DESIGN <i>CP</i>	DRAWN BY <i>CP</i>	DART AEROSPACE LTD HAWKESBURY, ONTARIO, CANADA	
CHECKED <i>[Signature]</i>	APPROVED <i>[Signature]</i>	DRAWING NO. DSI 9318	REV. A SHEET 1 OF 1
DATE 06.01.06		TITLE WASHER ADDITION	SCALE NTS
A	06.01.06	NEW ISSUE

DART SERVICE INSTRUCTION

TO AMEND INSTALLATION INSTRUCTIONS D350-607 REV. F

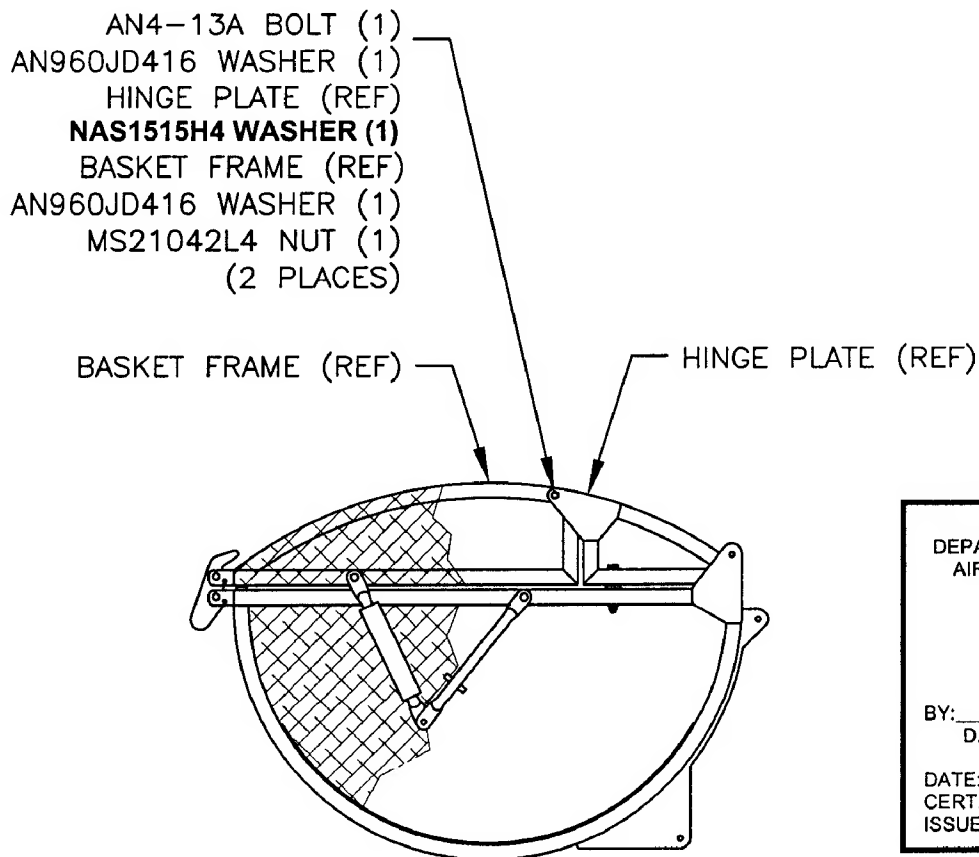
To reduce the possibility of damaging the finish, a **NAS1515H4** washer (2 places) has been added between the hinge plate and basket frame on the **D350-607-043/-047 Heli-Utility-Basket**.

The corrected bolt stackup from Figure 5 of installation instructions D350-607 Rev. F is given below:
